UNITED STATES PATENT AND TRADEMARK OFFICE

APPLICATION NO.	FILING DATE	FIRST NAMED INVENTOR	ATTORNEY DOCKET NO.	CONFIRMATION NO.
09/847,605	05/01/2001	Karl Jacob Haltiner JR.	DP-302846	7187

Office Action Summary

DETAILED ACTION

FIG 1

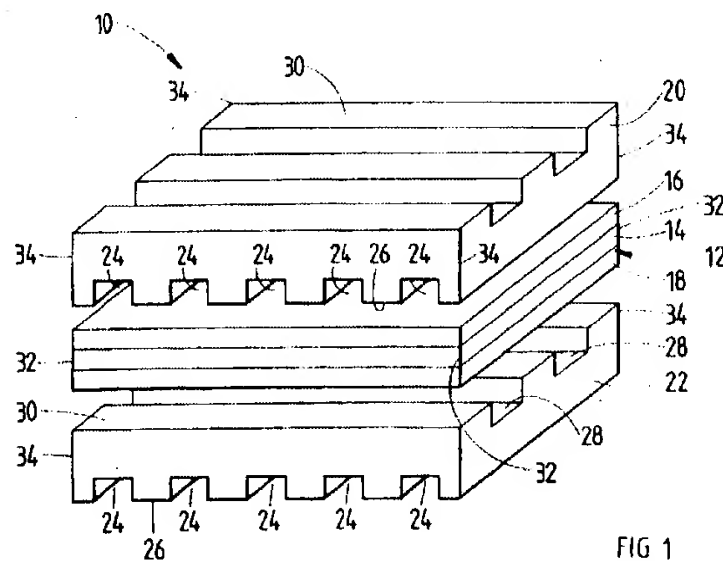
Figure 1 above illustrates a fuel cell assembly 10, the assembly comprises a fuel cell 12 comprising a solid oxide electrolyte central layer 14 with an anode layer 16 overlying one face of the electrolyte and a cathode layer 18 overlying the opposite face of the electrolyte. The fuel is sandwiched between a pair of interconnects 20, 22 which in use are in face contact with the anode 16 and cathode 18, respectively.

Figure 1 above depicts interconnects 20, 22 comprising gas flow channels 24 and 28. As can be appreciated from Figure 1, the interconnect comprises a plurality of top side surfaces 30 and underside surfaces 26 closely spaced to each other which act as contact points between the interconnect and electrode and wherein said top side surfaces 30 and underside surfaces 26 have small dimensional diameters. It is noted that the term "diameter" has been construed as the

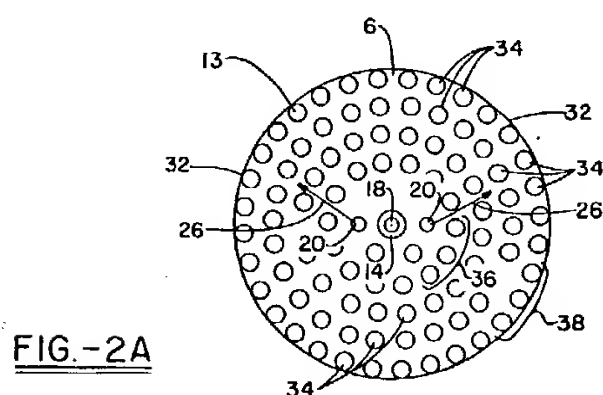
Figure 2A below shows a separator 6 defining microchannels 26 on either or both of its surfaces. Since the separators contact the anode and cathode surfaces, microchannels 26 defined

within the separator surfaces provide reactant channeling (col 6, lines 33-40). A microchannel 26 may be defined by a quantity of regularly spaced circular columns 34 (*contact points*) extending between surfaces (col 6, lines 45-48). It is disclosed that it should be understood that a preferred pattern of columns 34 would utilize many more columns than shown, with each column having a diameter on the order of about 1 mm or less (col 6, lines 58-61/col 7, lines 48-52). The cell and stack diameters are typically about 50 to about 80 mm (col 5, lines 10-12). The specific contact point density is apparent upon inspection of the separator plate 6 as illustrated in Figure 2A.

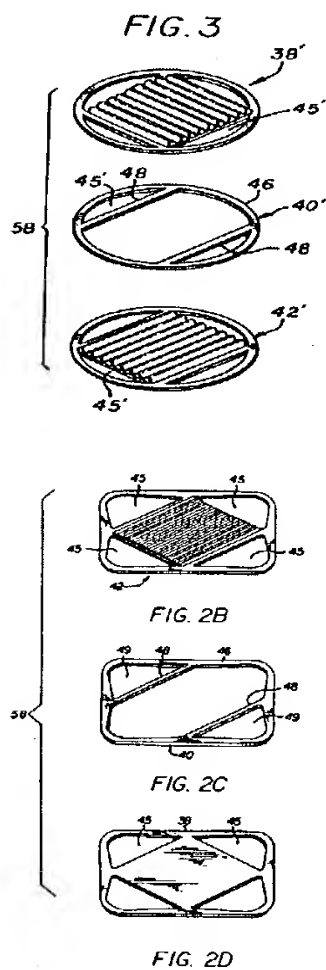
With respect to the specific flow passage depth and the surface area, it would have been obvious to one skilled in the art at the time the invention was made to make the interconnect of Badwal et al by having specified flow passage depth and surface area of Ruhl et al because Ruhl et al teaches that the specific depth of flow passage (channel) and surface area relationship should defines a channel pattern wherein the channel cross-section is enhanced such that reactant gas flowing through the passages (channel) achieves tailored local flow, pressure, and velocity distributions. Accordingly, those of ordinary skill in art would find motivation to make the specified flow passage depth and surface area relationship in the interconnect of Badwal et al as Ruhl et al teaches that such flow passage depth and surface area relationship (overall dimension), in general, achieve a specific target overall pressure drop that minimize electrical resistance and improves reactant gas distribution.
